Project 215571.00
22 July 2022
R.001.Rev0
MJJ

Report on Geotechnical Assessments
Proposed Additions
Pygmy Possum Lodge, Lot 108 DP1242013, Charlotte Pass

Pygmy Possum Lodge, Lot 108, DP 1242013, Charlotte Pass Village

Date	3/6/22
Drawn	DS
Checked	
Scale	
Drawing No.	
#220-	2

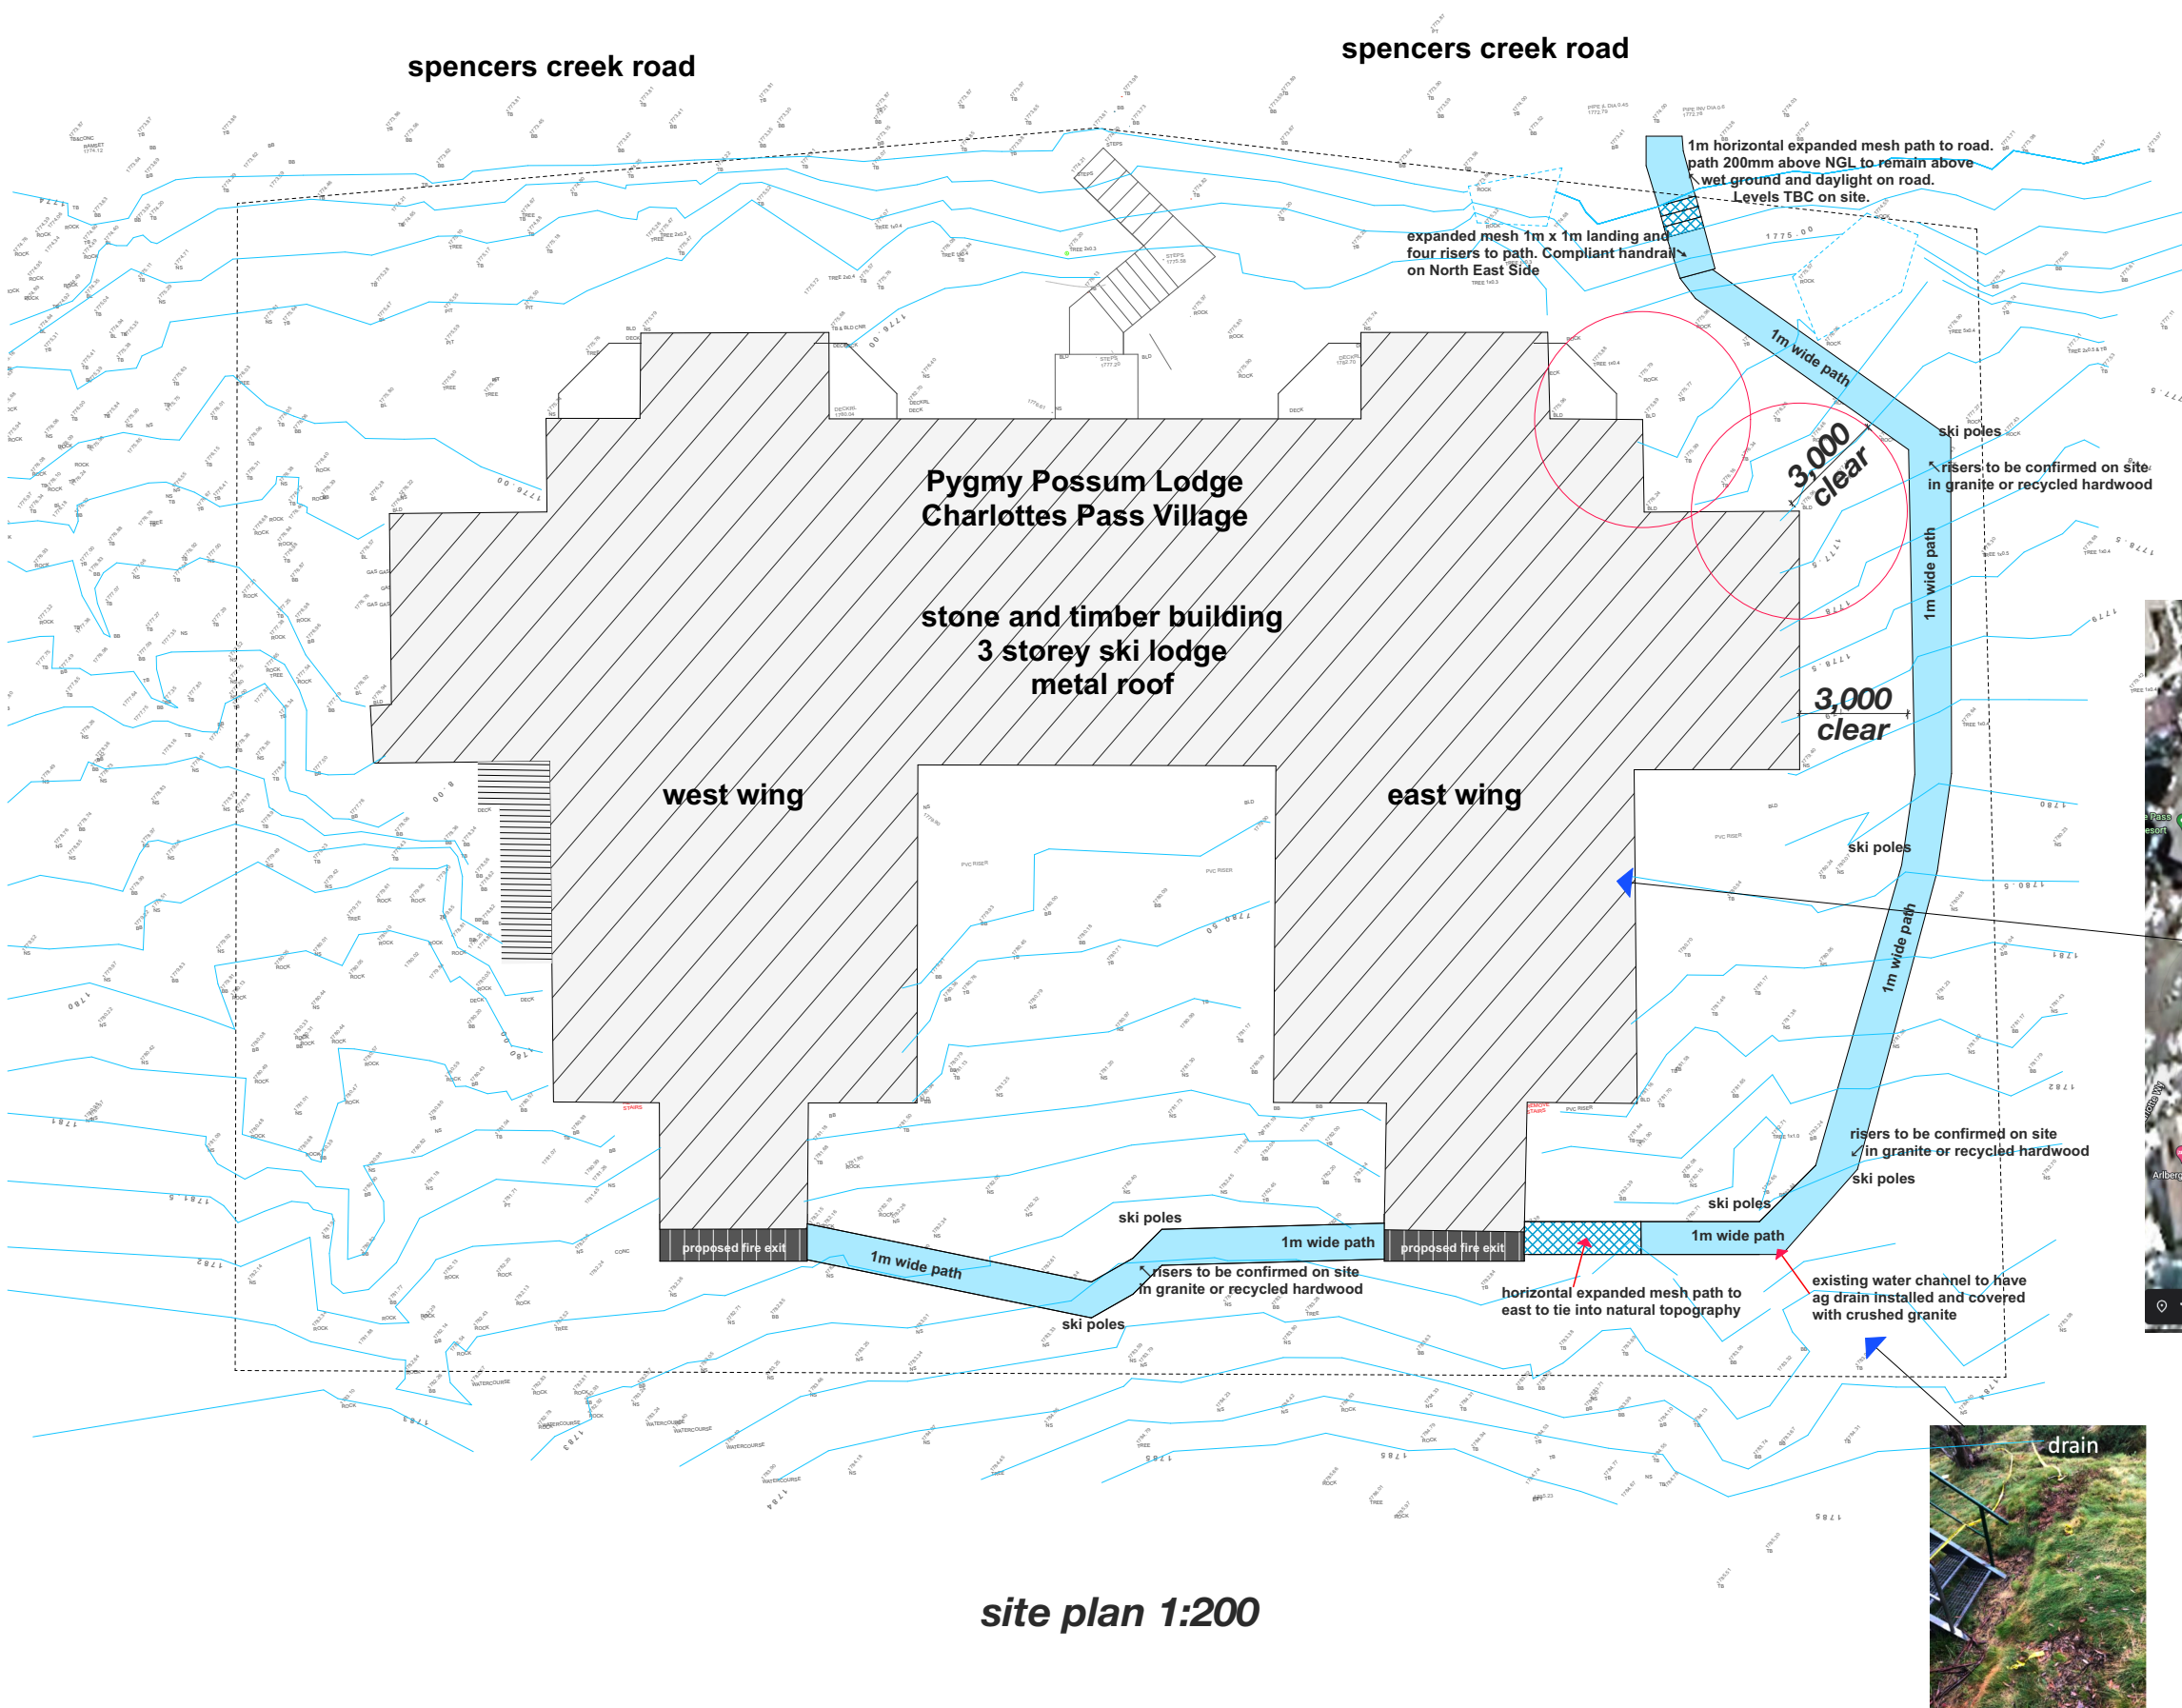
- All new footings must be founded below the zone of influence of any adjacent/existing footings.
- Site excavation and filling for the fire escape pathway should be limited to less than 0.5 m, and where required to exceed for the fire escape pathway this value, it should incorporate a suspended steel mesh grate (supported on piers in to weathered rock) to avoid excavation or filling.

**west wing fire escape
[section view] scale 1:20 detail**

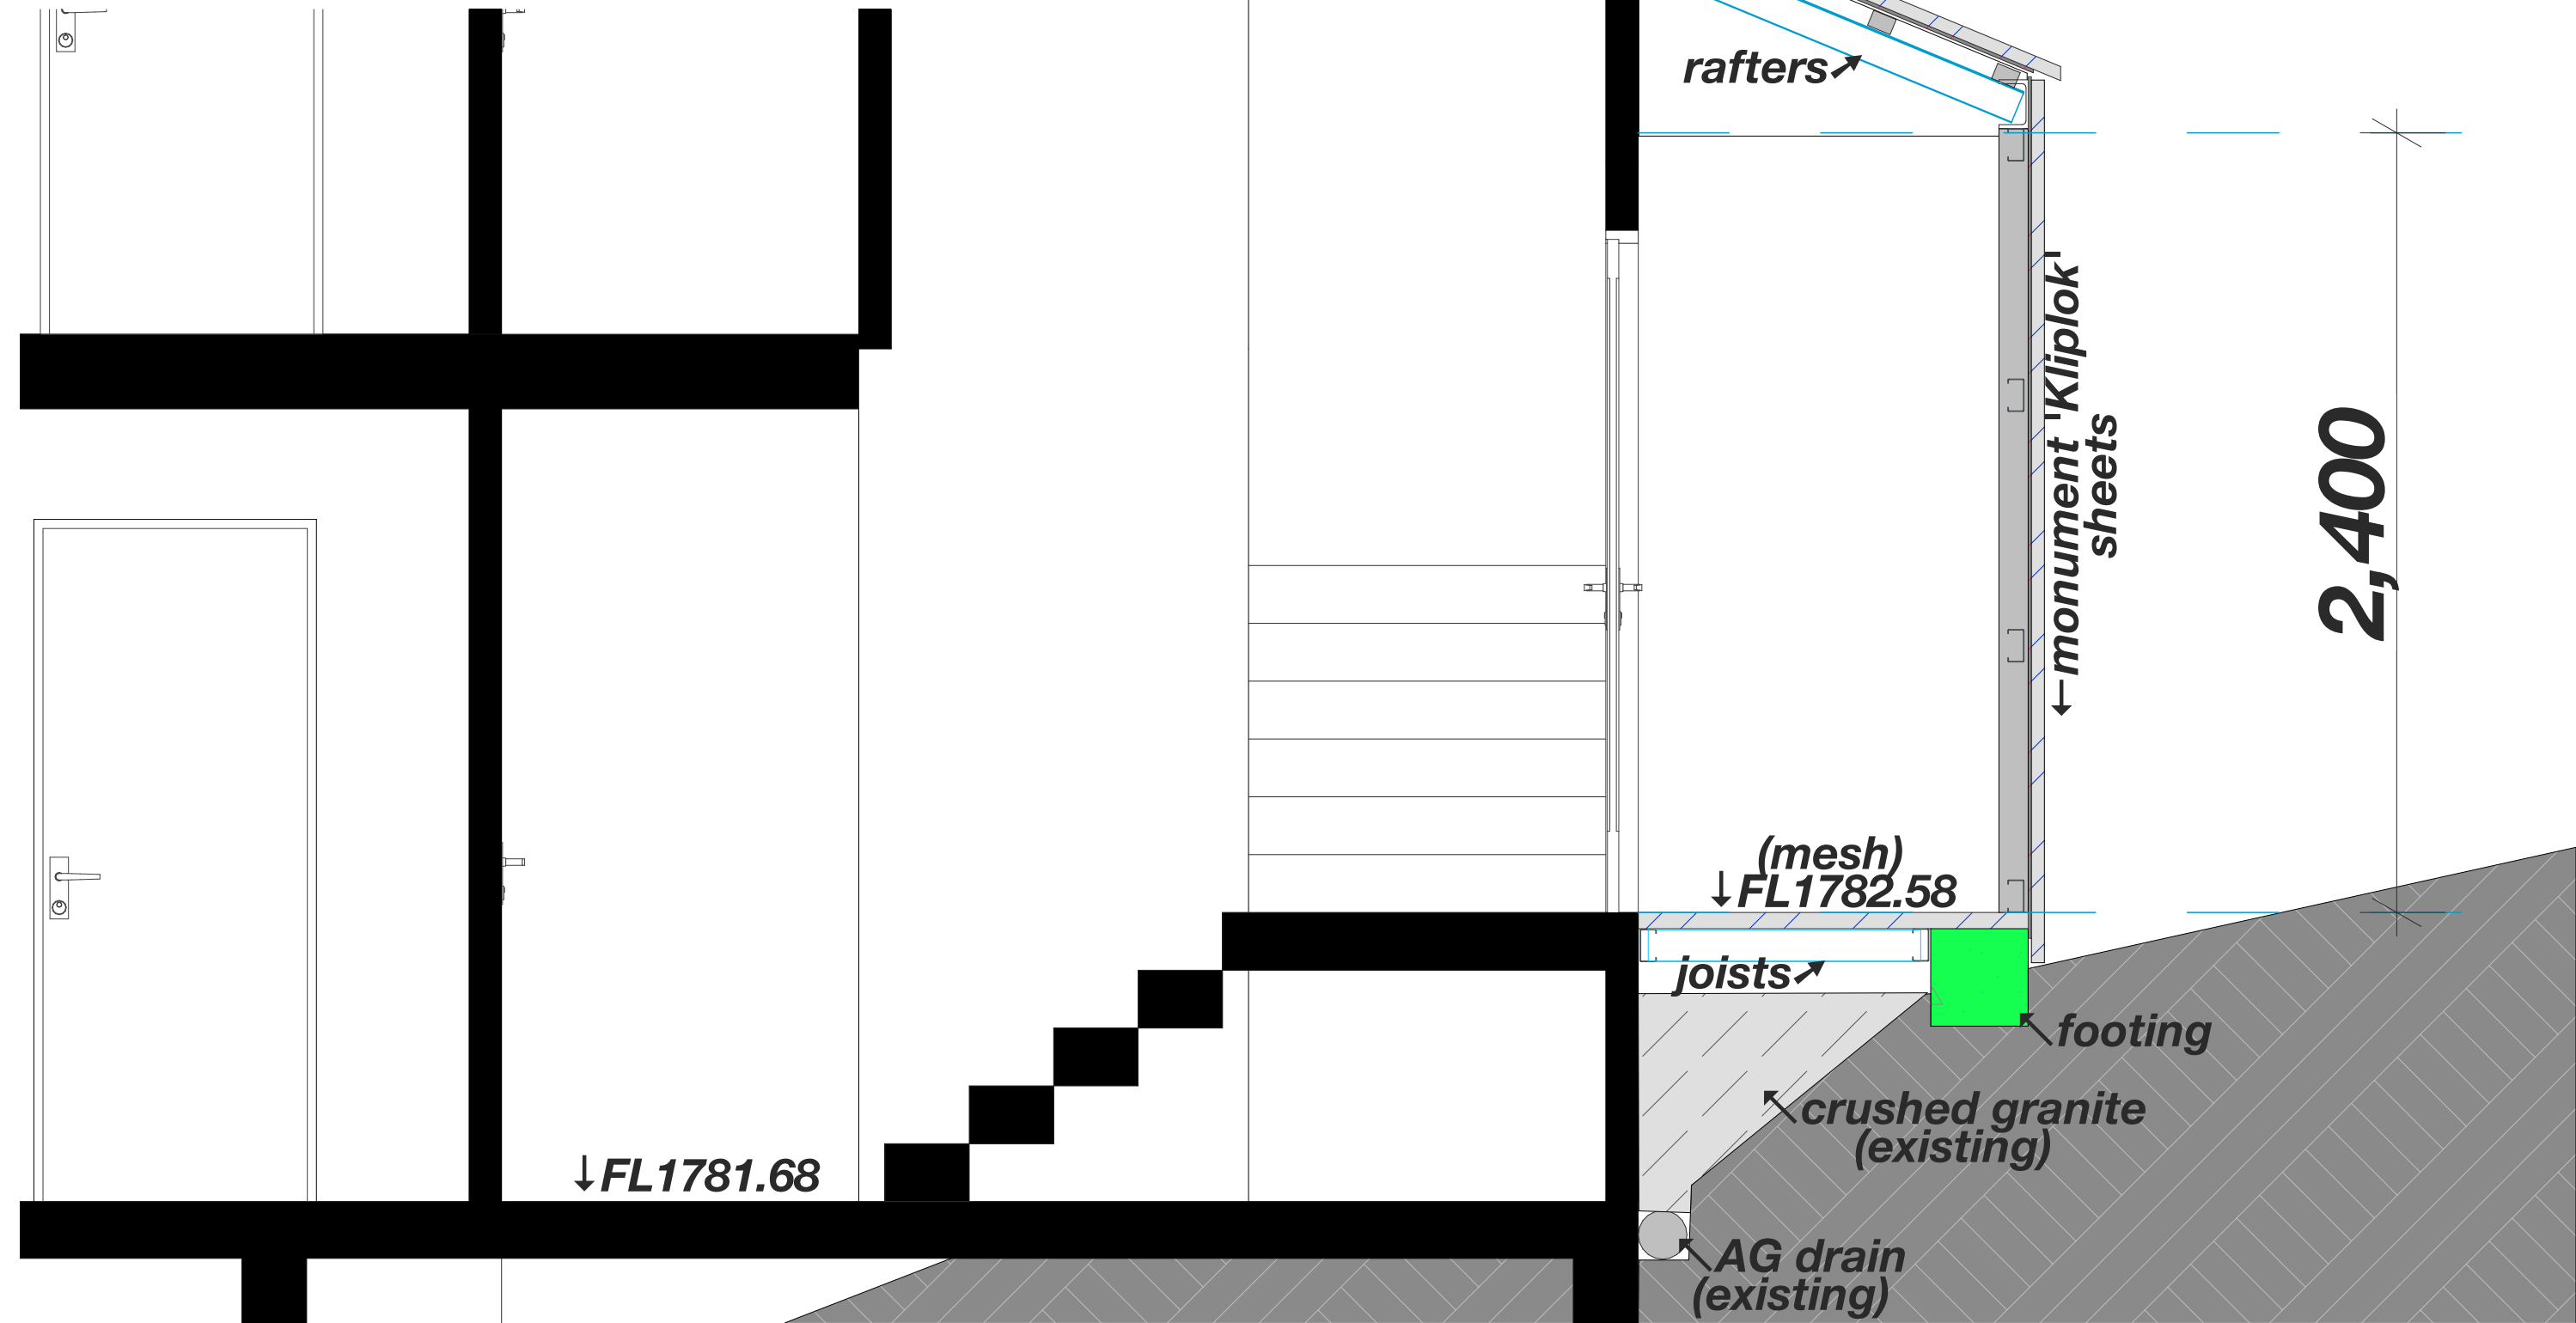
- All loads from the new fire escapes are transferred through the overburden soils (possibly prone to soil creep) to within the weathered rock. A minimum socket of 0.5 m into weathered rock (minimum extremely low strength) is recommended with an allowable end bearing pressure of 300 kPa.

- We would recommend that all footing excavation be viewed by a Geotechnical Engineer to confirm suitability of the founding stratum.
- Site surface drainage or and existing subsurface drainage systems must not be compromised by the proposed works.
